**Tegel Foods Ltd Resource Consent Application CRC185584 - Response to PDP
Review of Protein Recovery Odour Management System and Update to Proposed
Ventilation Upgrade**

ECan engaged Pattle Delamore Partners Ltd (PDP) to provide a review of the design and likely effectiveness of Tegel's proposed upgrade to the PRP odour control system. This document provides a response on Tegel's behalf¹ to the conclusions and recommendations of PDP's review report, dated 12 June 2019.

Figure2: Process flow diagram for by-products rendering, air extraction and wastewater conveyance activities at the PRP (revised upgrade configuration)

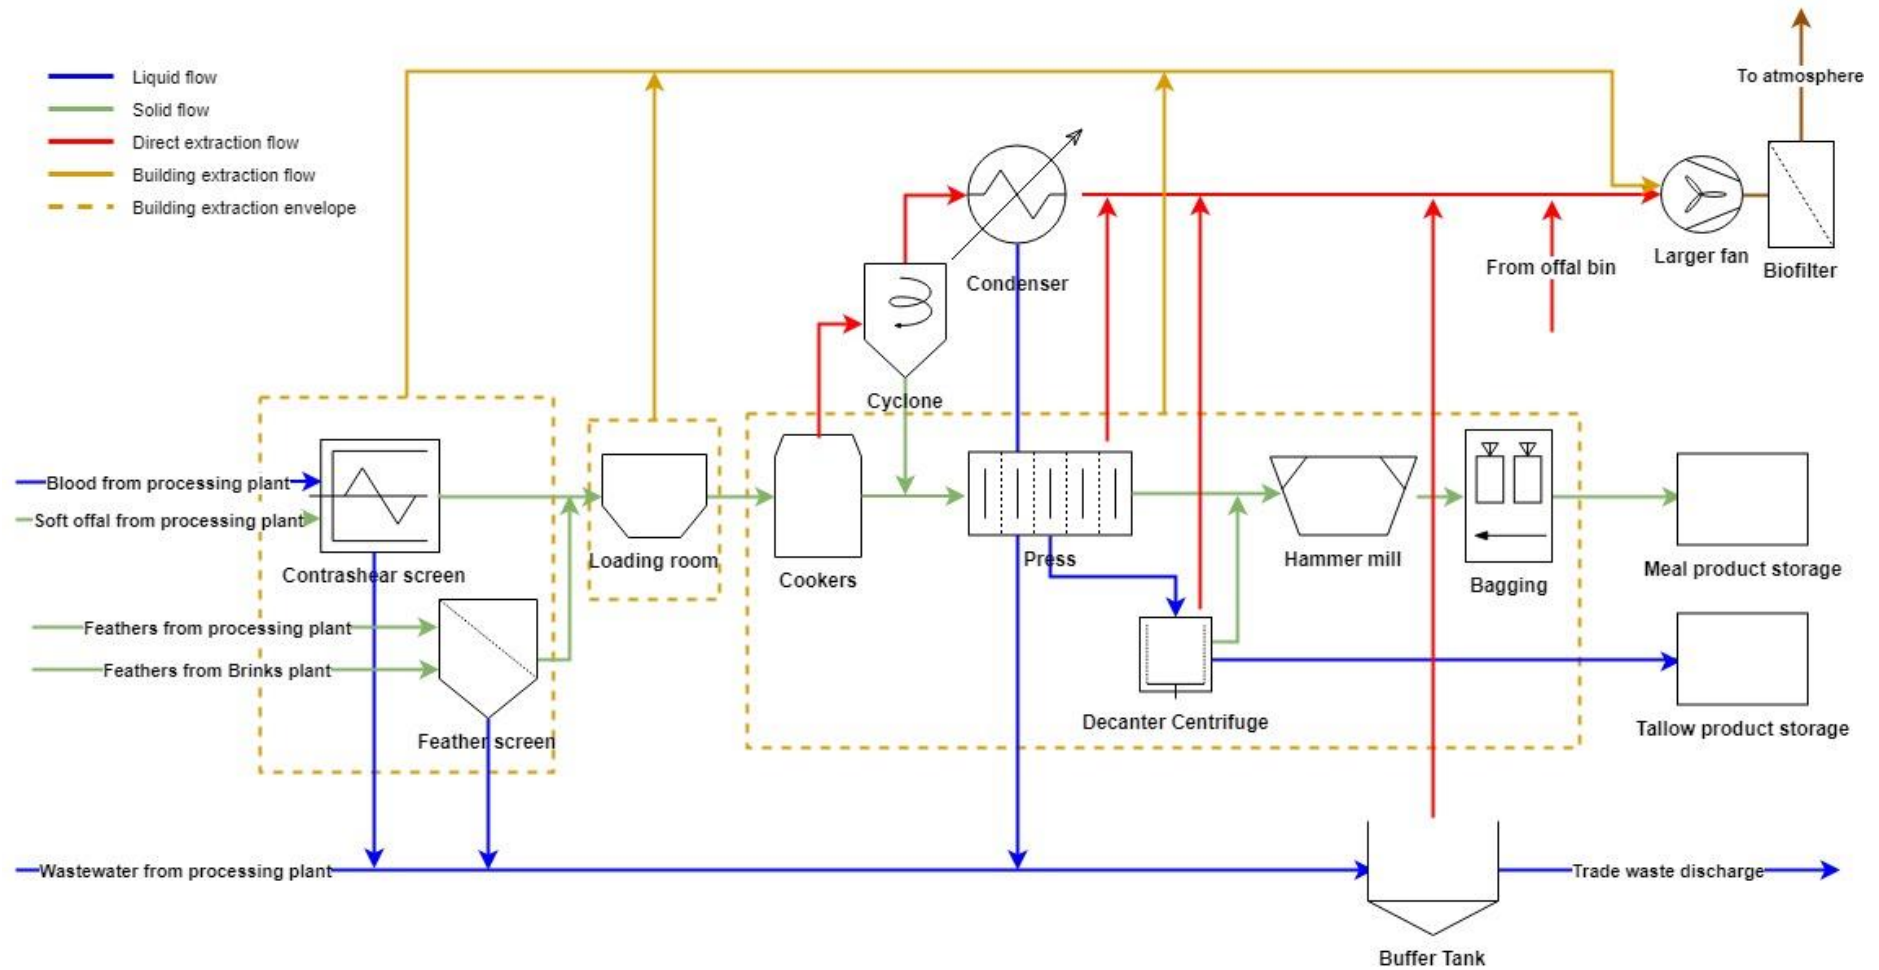
As noted above, the proposed upgrade to the PRP ventilation system has been modified. The modified extraction scheme described in section 3.1 includes direct extraction from the press and press auger screw as well as from the decanter. As such, we consider that all of the key hot sources will be included in point source extraction.

As well as increasing the building extraction from the cooker room, the ventilation upgrade now includes direct hood extraction from the press/meal auger and decanter centrifuge.

A larger fan will now be installed to replace the existing PRP extraction fan, capable of extracting air from the PRP at a rate of up to 12.6 m³/s, and increase from the upgrade ventilation rate proposed in the AEE for this application of 9.3 m³/s.
